Wisconsin Department of Transportation

Proposal #07: 1060-27-74, WISC 2025597

I-94 East West, Early East Leg

This is Addendum No. 03, which provides for the following:

Addendum No. 03 ID 1060-27-74 **Revised Sheet 829** September 4, 2025

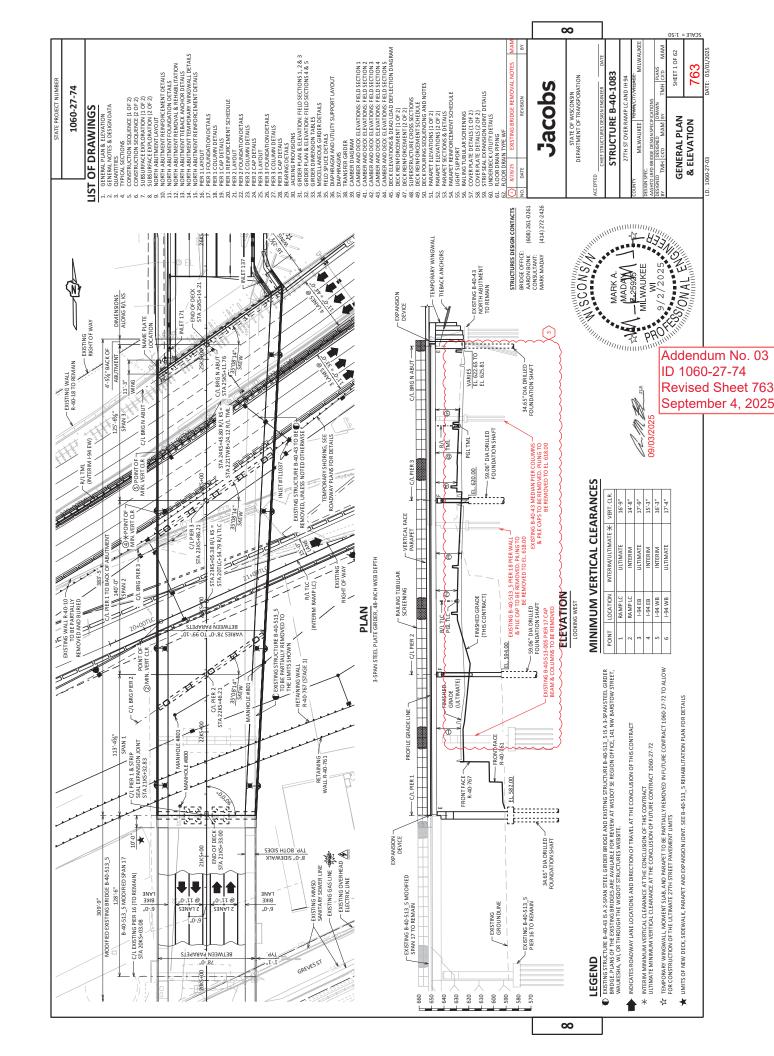
392-393	Sewer Pipe Removals, Abandoning Sewer, and Reconnecting Storm Sewer tables
399	Miscellaneous Quantities – Revised station/offset for manhole
404	Miscellaneous Quantities – Temporary Shoring (R-40-10) quantity revised
763	Structures Plan (B-40-1083) – Added minimum removal limits elevation
829	Structures Plan (R-40-761) – Removed wall system note
852	Structures Plan (R-40-761) – Revised MSE panel embedment
865	Structures Plan (R-40-767) – Removed wall system note
866	Structures Plan (R-40-767) – Revised MSE panel embedment
867	Structures Plan (R-40-767) – Revised MSE panel embedment
901-903	Cross Sections – Revised location of eastbound barrier location
